BOARD OF APPEALS

P&Z STAFF REPORT Board of Appeals Meeting, June 3, 2026

Case: **V-26-9 4630 Mount Paran Parkway**
Staff Contact: LaQuita Williams(lwilliams@sandyspringsga.gov)
Report Date: May 27, 2026

Case: **V-26-19 – 6565 Williamson Drive**
Staff Contact: LaQuita Williams (lwilliams@sandyspringsga.gov)
Report Date: May 26, 2026

Site Plan

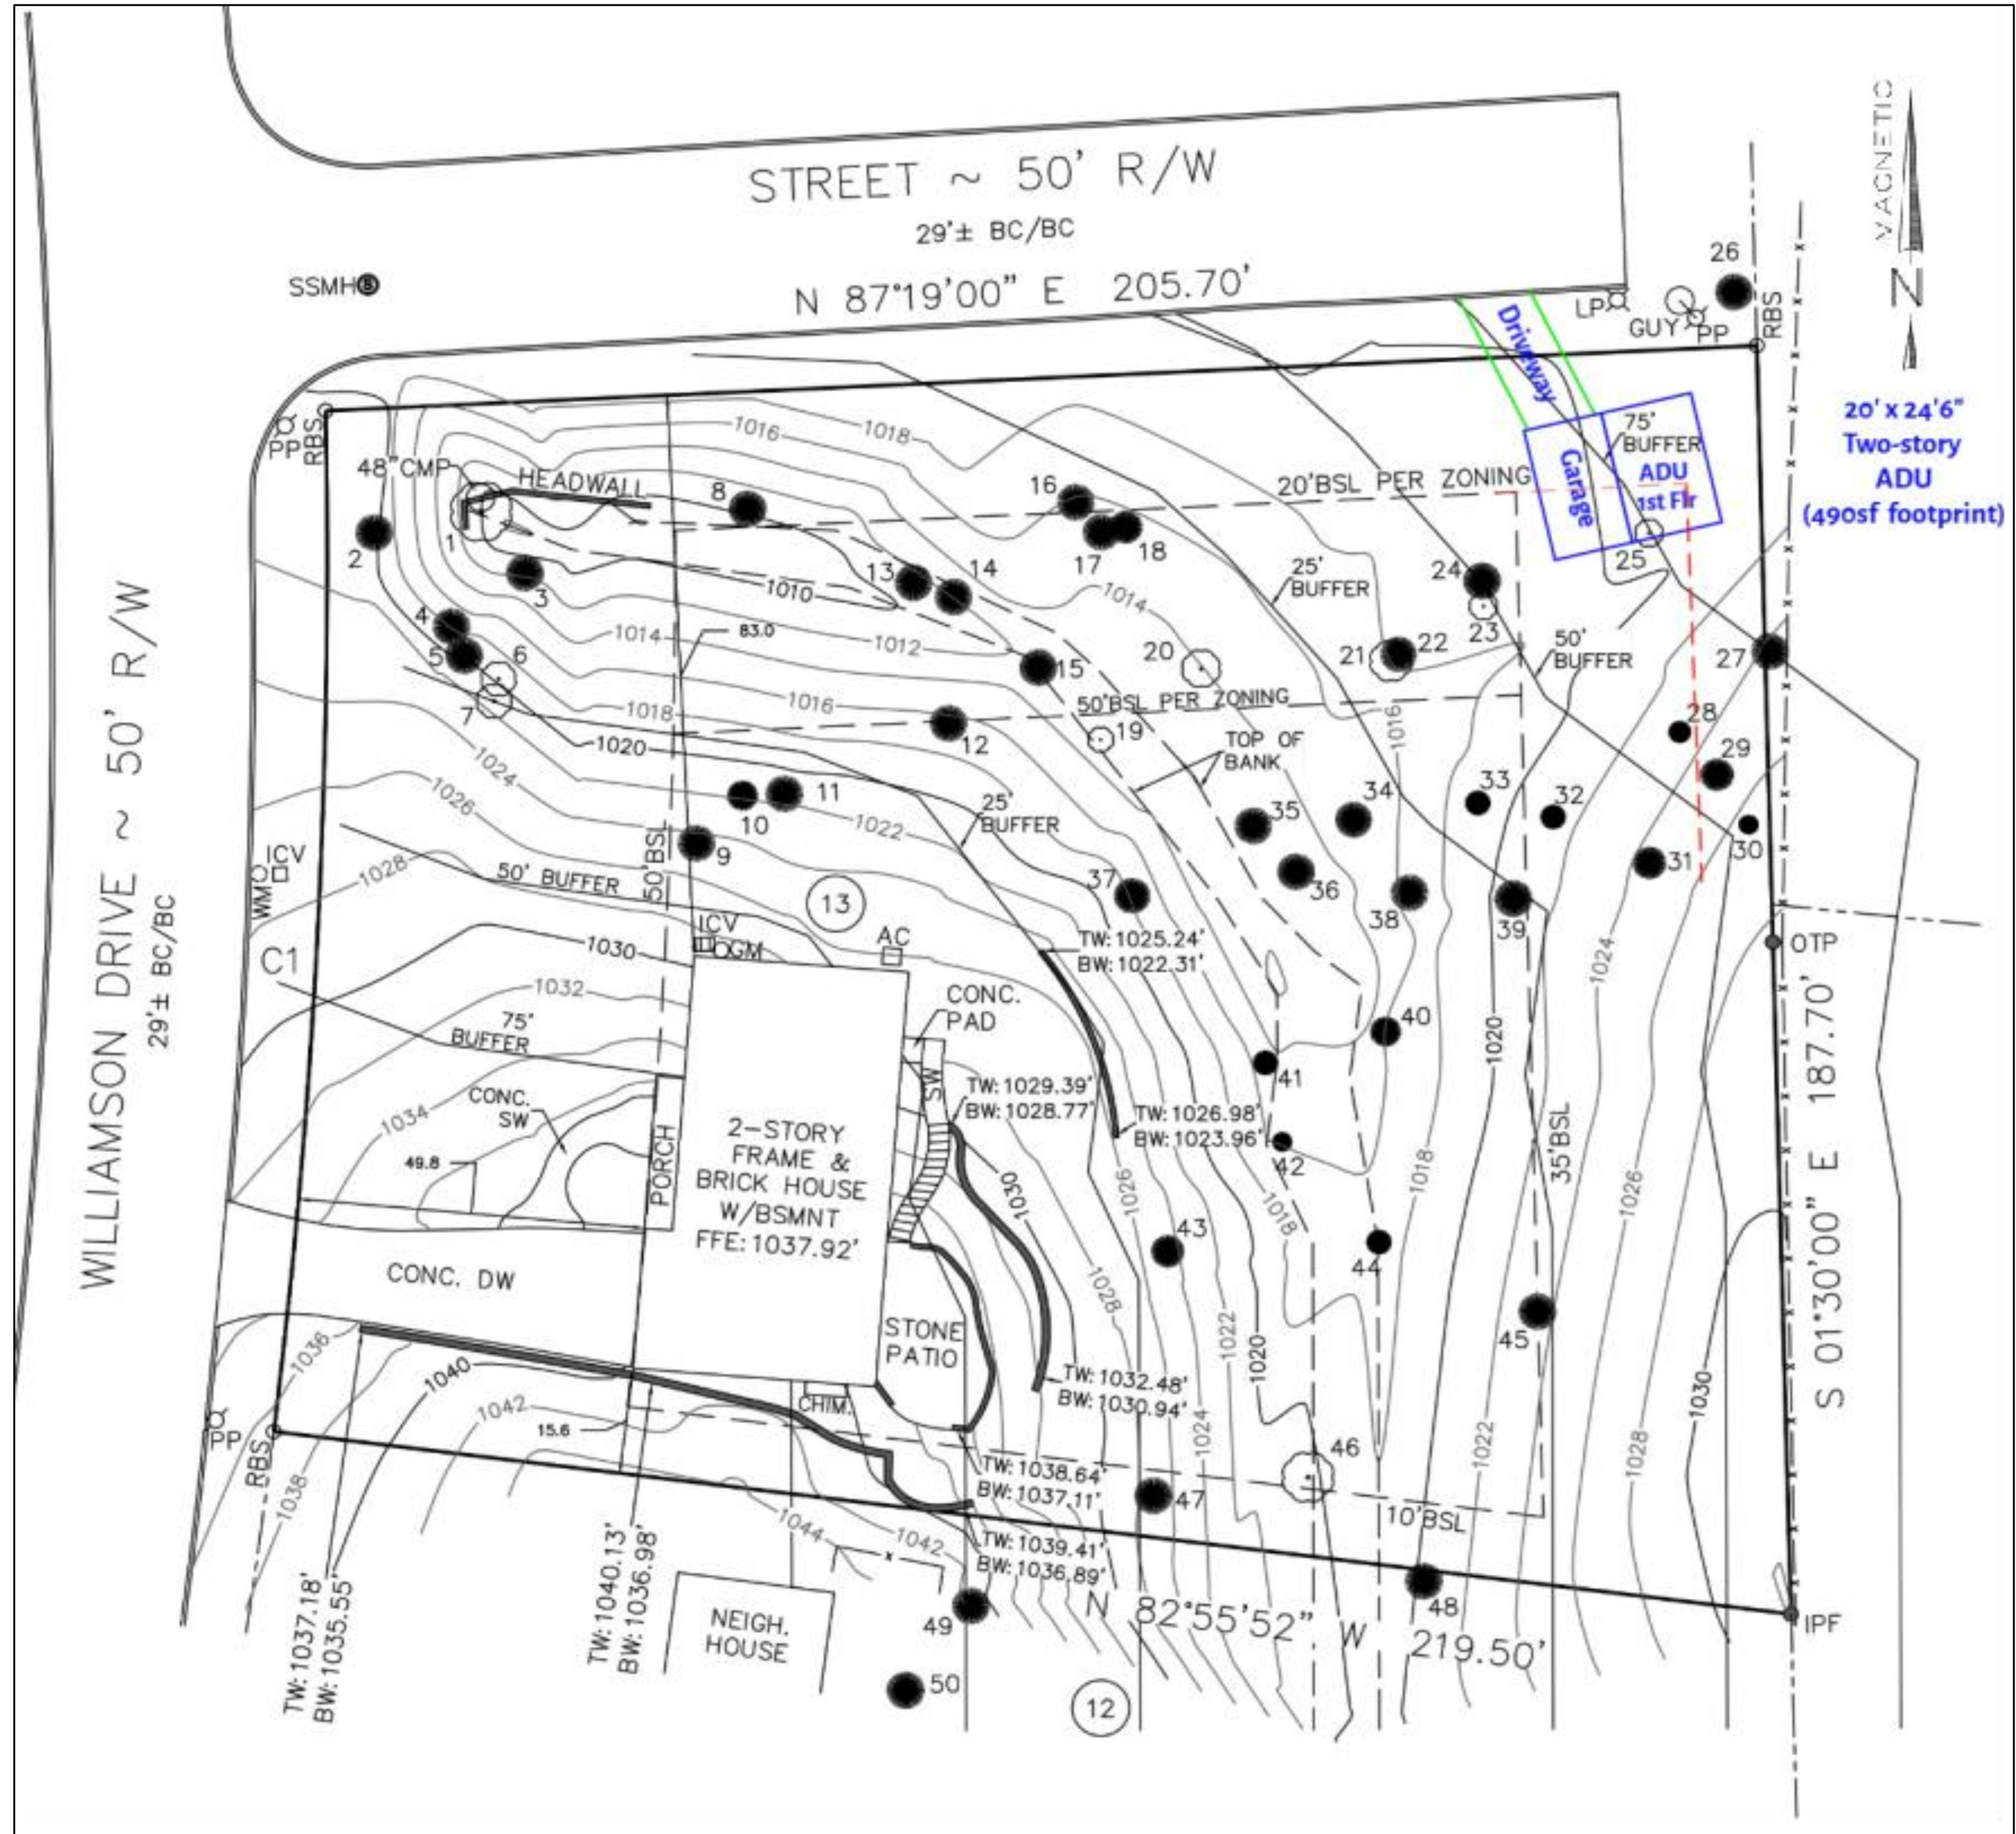
The property was platted in 1957, prior to December 12, 2005, and the existing home was constructed in 1964. The subject property is significantly constrained by stream buffers. A stream traverses the rear yard, resulting in the associated stream buffers, 25-foot state buffer, 50-foot undisturbed buffer, and 75-foot impervious surface setback, encompassing majority of the existing home and the entire rear yard. The stream also creates a ravine that causes the land to slope significantly towards the creek further limiting the amount of buildable space. Due to these physical constraints and existing site conditions, development of the property is limited without the requested variance. The applicant's request to encroach into the side, rear and impervious surface setbacks is intended to minimize disturbance and avoid further encroachment toward the stream buffer area.

Strict adherence to the minimum buffer and setback requirements would create an extreme hardship due to the various conditions of the site. A stream crosses the rear of the lot, resulting in the buffers encompassing a substantial portion of the site. In addition, the site's topography further constrains reasonable development options. The proposed encroachments are intended to minimize impacts to the stream corridor. Given the building setback lines and the stream buffers, there is effectively no location on the property that is buildable without a variance.

The proposed variance has a limited scope and the intrusion is minimum. The applicant's proposal is as far away from the creek as practicable.

- Staff recommend **Approval with a Condition** of Variance V-26-19 a request for relief from Div. 9.2., Sec. 7.3.1.D., and Sec. 7.8.24. to allow a minor accessory structure to encroach into the 20-foot side, 35-foot rear, 75-foot impervious surface setbacks and exceed the minimum height with the following condition:
 1. That the accessory structure does not exceed 24 feet in height and
 2. That the construction be substantially similar to the provided site plan.
